CALIFORNIA ENERGY COMMISSION1516 NINTH STREET
SACRAMENTO, CA 95814-5512Main website: www.energy.ca.gov**DEPARTMENT OF FISH AND GAME**1416 NINTH STREET
SACRAMENTO, CA 95814Main website: www.dfg.ca.gov

April 29, 2011

The California Energy Commission (Energy Commission) and the California Department of Fish and Game (Fish and Game) (or collectively, “the Agencies”) appreciate this opportunity to comment on the Draft DOE-BLM Programmatic Environmental Impact Statement for Solar Energy Development in Six Southwestern States (Solar DPEIS or DPEIS) announced in the December 17th, 2010 *Federal Register* Notice of Availability. The Energy Commission and Fish and Game have participated in the scoping process for the Solar DPEIS, and have been cooperating agencies during the development of the DPEIS. The Energy Commission led the California Interagency Working Group for the Solar DPEIS, and Fish and Game has participated jointly with the Energy Commission in these efforts. Our comments here are limited to the California portion(s) of the Solar DPEIS.

BLM Solar DPEIS Solar Development Areas within the Desert Renewable Conservation Plan (DRECP) Area: Potential Conflicts With Priority Mitiga

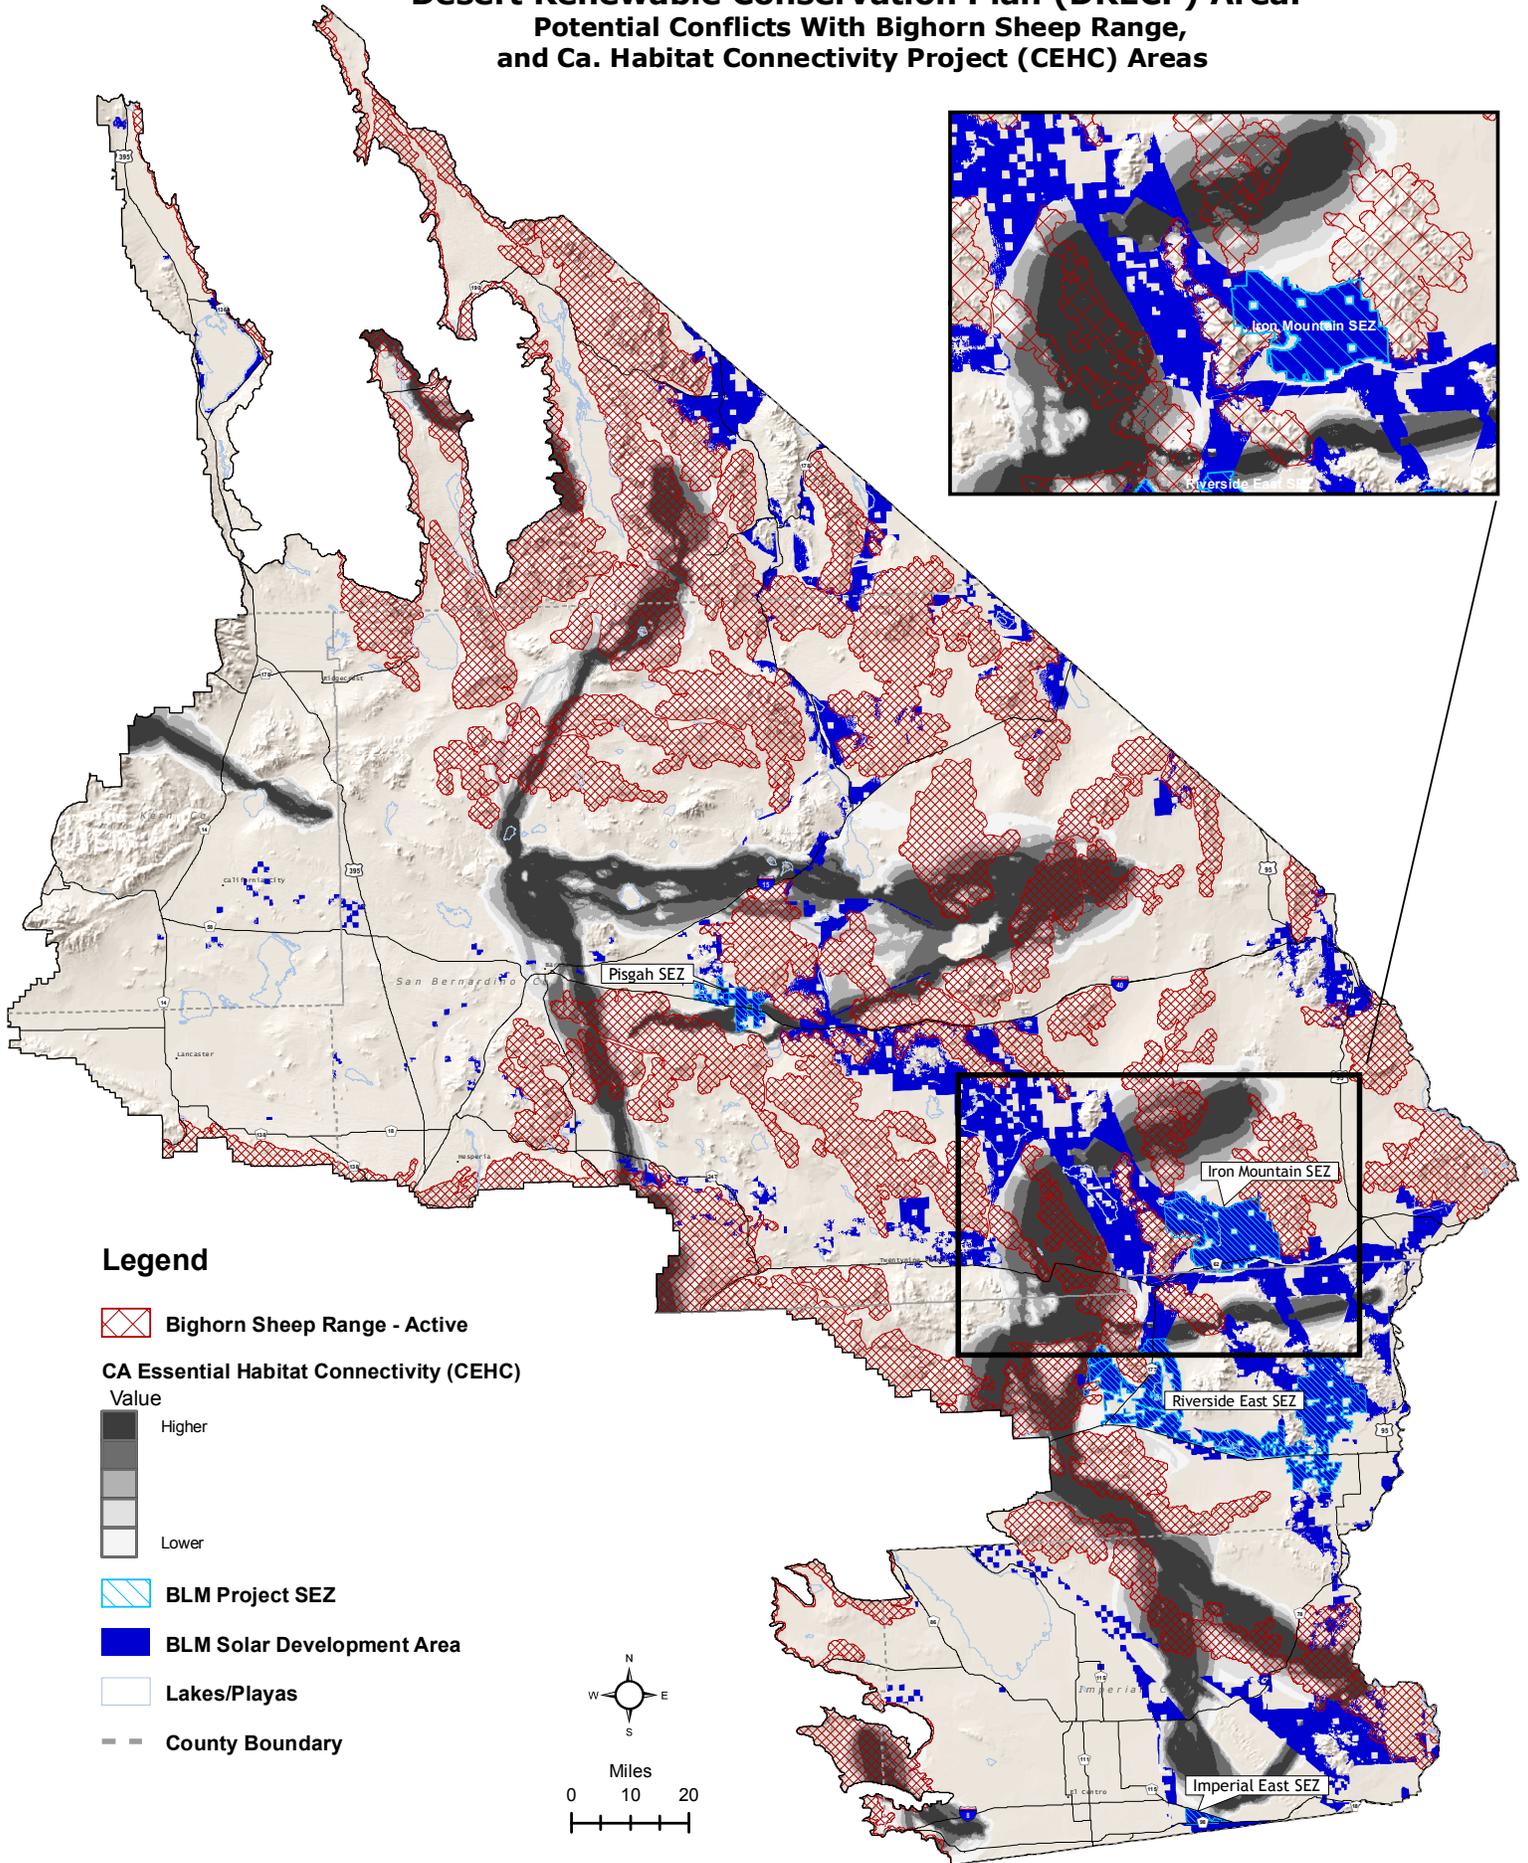
Our concerns about the potential conflicts between preliminarily identified conservation opportunities for the DRECP and the Solar Energy Program (preferred alternative) of the PEIS are depicted in the attached maps 1-3 (Attachments 1, 2 and 3), in which the BLM lands emphasized for solar energy facility development are shown within the DRECP Area. Biological information, based on GIS layers that Fish and Game is contributing to the preliminary DRECP conservation framework, is also shown. An explanation for each of the five layers accompanies the attached maps (Attachment 4). Overlap of these layers with the Solar PEIS preferred alternative's lands indicates a potential conflict between the conservation planning efforts of the DRECP and the Solar PEIS preferred alternative designation of those lands as emphasized for development. Overlap of four of these layers with the BLM Solar Energy Program areas appears significant. While the bighorn sheep range layers do not show a high level of overlap, the proximity of these active ranges (see inset in Map 2, or vicinity near the Pisgah SEZ) to the BLM Solar Energy Program lands is cause for concern, as connectivity between these ranges is important for the viability of bighorn sheep populations.

The analyses the REAT Agencies have initiated for the overall DRECP Conservation Strategy will be more detailed than those in the Solar DPEIS. The Agencies recommend deferring a decision on the initiation of BLM land use plan amendments for the lands identified that are outside of the SEZs, or not including these additional lands in the NEPA preferred alternative, pending further analysis associated with the DRECP Planning effort.
